# RENESAS TECHNICAL UPDATE

Product Category	MPU & MCU	Document No.	TN-16C-A218A/E	Rev.	1.00
Title	Errata to R32C/160 Group Hardware Manual		Information Category	Technical Notification	
Applicable Product	R32C/160 Group	Lot No.	Reference Document	R32C/160 Group Hardware Manual Rev. 1.02 (REJ09B0516-0102)

This document describes corrections to the R32C/160 Group Hardware Manual, Rev. 1.02.  
The corrections are indicated in red in the list below.

**Figure 26.2 Addresses for ID Code Stored**

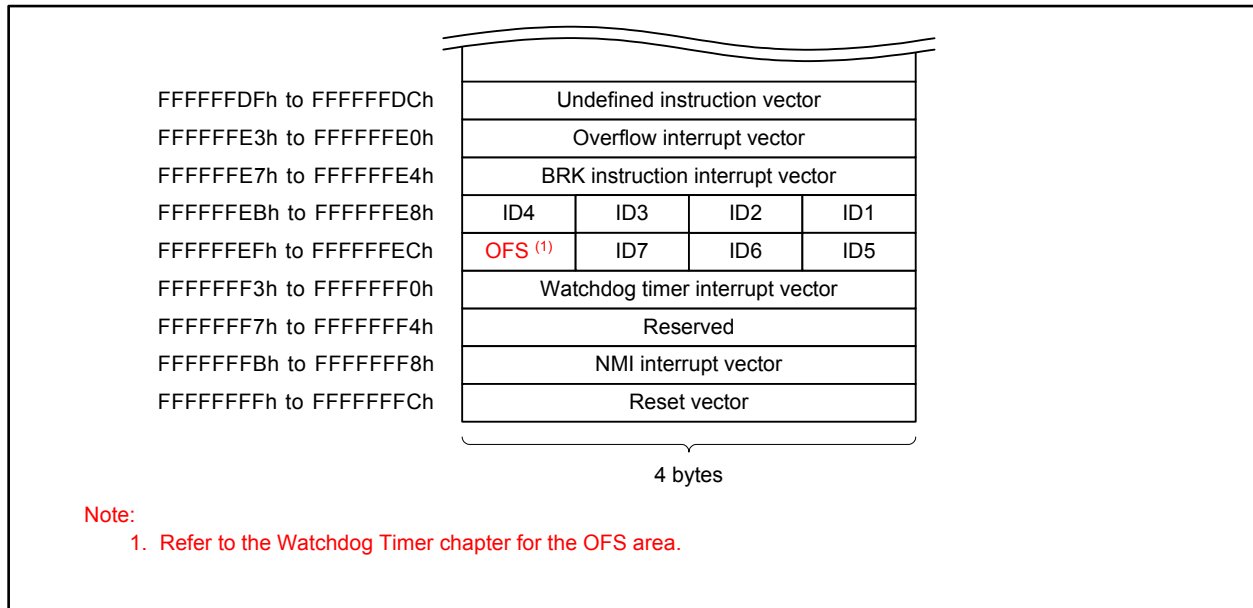
•Page 480 of 572, Figure 26.2 is corrected as follows:

Figure 26.12 Read Timing

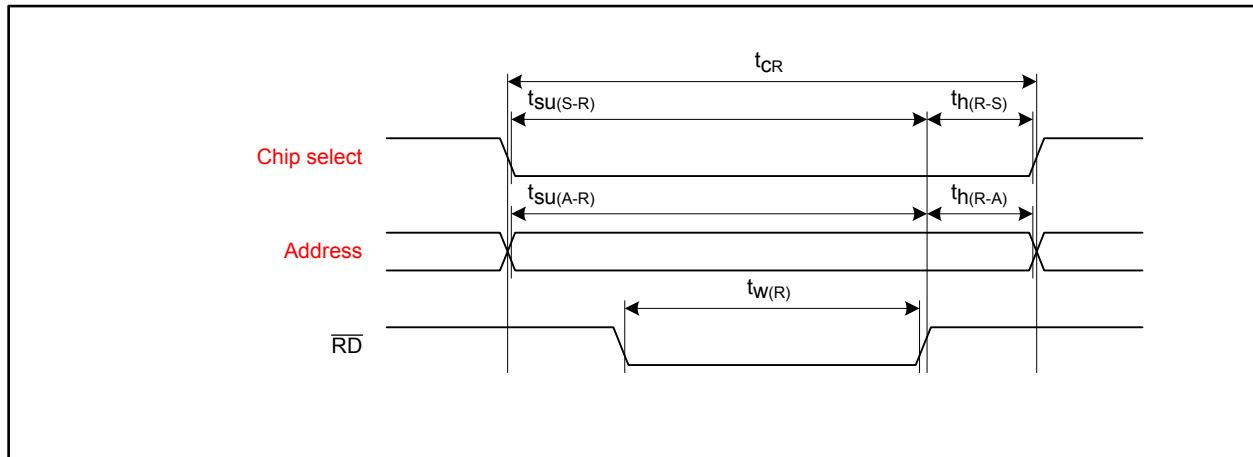
- Pages 488 and 490 of 572, descriptions in Figures 26.12 and 26.13 are corrected as follows:

**Figure 28.5 Flash Memory CPU Rewrite Mode Timing**

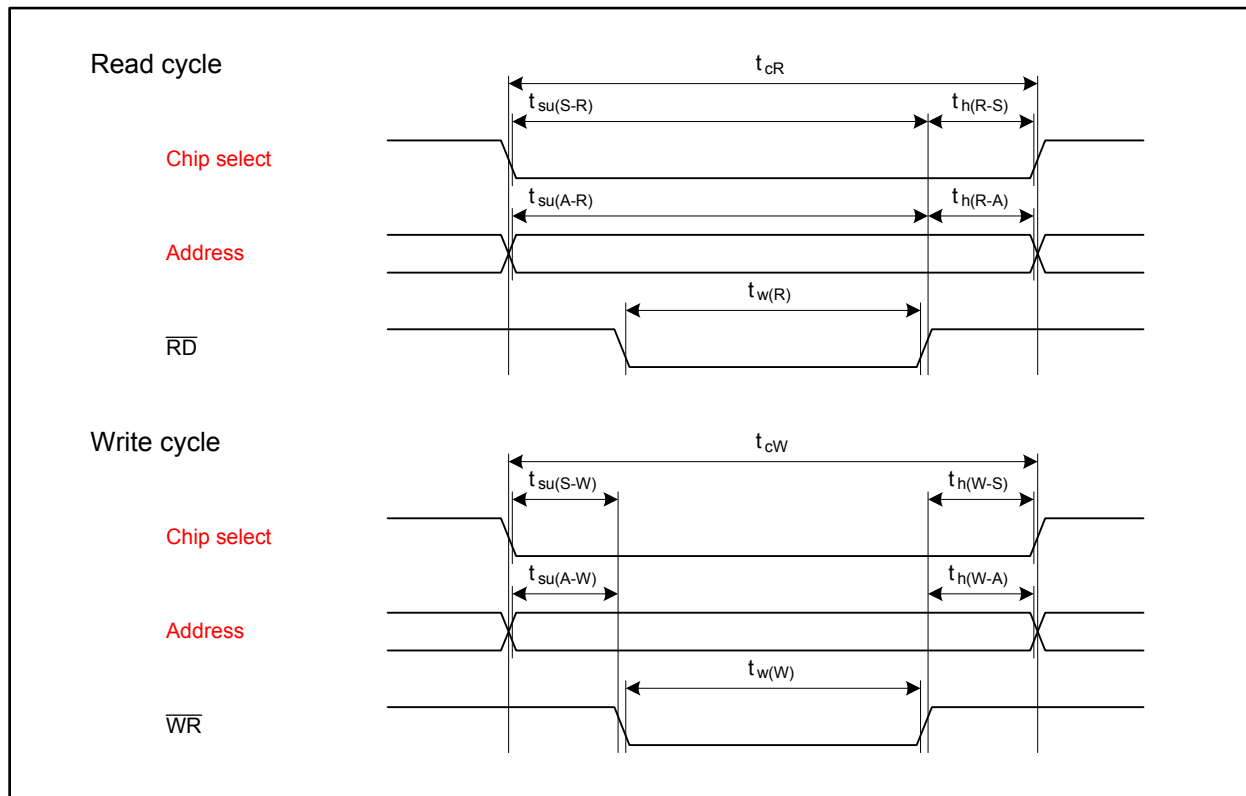
- Page 527 of 572, descriptions in Figure 28.5 are corrected as follows:
